POWER GRID COMPANY OF BANGLADESH LIMITED
Dhaka and Western Zone Transmission Grid Expansion Project

Design, Supply, Installation, Testing & Commissioning of Rampura-Bashundhara 132kV Underground Cable Line on Turnkey Basis (Package-2)
Invitation for Bids No.: 27.21.0000.101.07.312.21.5537 dated December 22, 2021
[OCB No.: PGCB/ADB/3853-BAN/DWZTGEP/UGTL/P2]

CLARIFICATION NO.1

Title
Typical Joint Arrangement
for 6 Joints in one Joint Bay

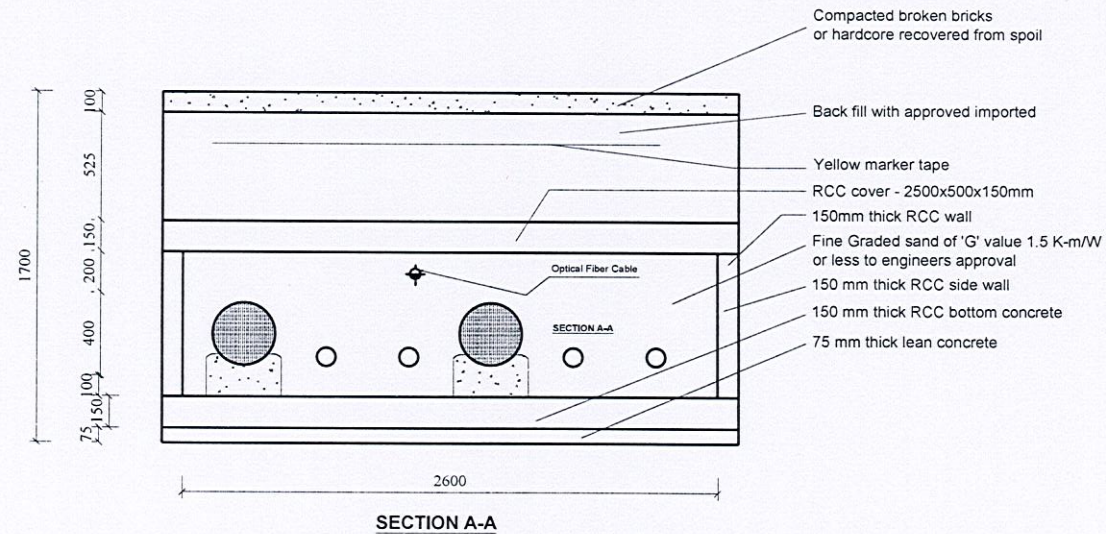
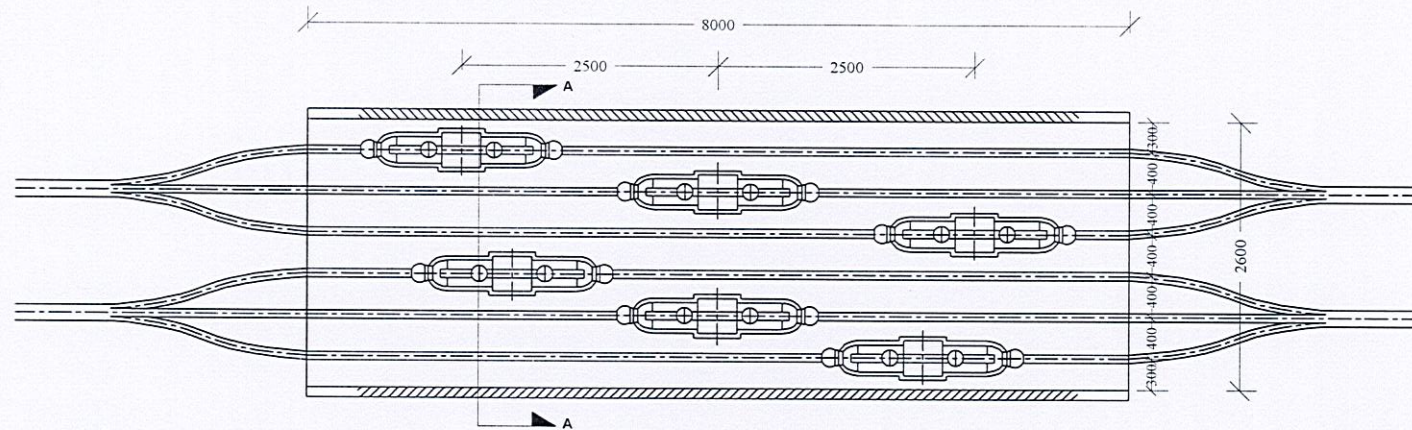
Sl. No.	Reference and Queries of Prospective Bidders	Reply(PGCB)
38	<u>Vol.2 of 3, Section-11A, Power cables, cable terminating accessories and cable laying, cl.no.11A.15.5</u> From the referred clause it is mentioned that "Cable trenches shall be constructed for directly buried cables as per drawings of Drawing Section.". However, cable trench drawings are not available along with tender documents. We request PGCB to furnish the following drawing: a) Cross section drawing for 132kV double circuit transmission cables (direct buried) b) Cross-section for Road and rail crossing c) Concrete cable trench drawing (Inside substation) for 132kV double circuit transmission cable d) Standard drawing of cable bridge e) Joint bay drawing for 132kV Double circuit cable	Please follow the Attachment-1 for the following drawings:- 1) Typical Trench for 132kV Cables 2) Typical Road Crossing Drawing 3) Typical Warning Tape Drawing 4) Typical Joint Arrangement for 6 joints in one joint bay. For Cable Bridge design please follow the bid document.
